# Walnut Tree Village II

# King's Mark Environmental Review Team Report

#### **Environmental Review Team Report**

November 1998

Figure 3

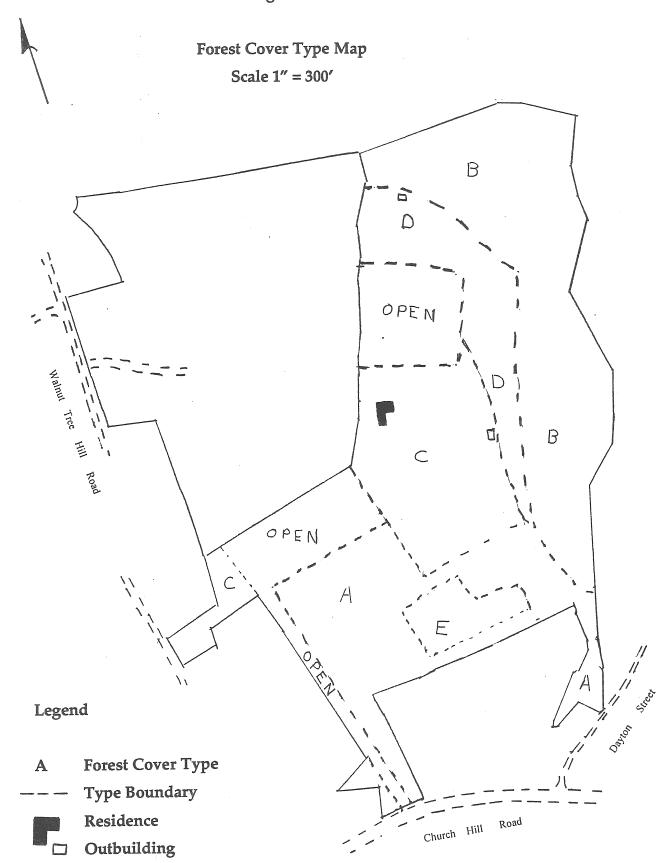
The forested vegetation description for the site can be divided into four cover types (see Figure 3 - Forest Cover Type Map).

The proposed housing development will convert approximately 11 acres (37%) of the forestland to non-forested. Cover Types B, C, D and E will be most impacted. The construction of the buildings, roads, parking lots and utilities will fragment the continuous forest cover into fingers and islands. Overall concern therefore should be for maintaining and enhancing the vegetation that can remain. It would be desirable to incorporate the retention of individual trees and clumps of trees and shrubs into the final site plan. Trees are sensitive to changes in soil conditions. Development activities near trees may disturb their root zone and ultimately their health and vigor. Dead and dying trees reduce the aesthetic appeal of the property, become a safety hazard, and are

In type B the hemlock growth is currently stressed by the scale infestation. Development activities could further stress these trees and increase the rate of mortality. Hemlocks should not be considered as a tree to retain around the developed area.
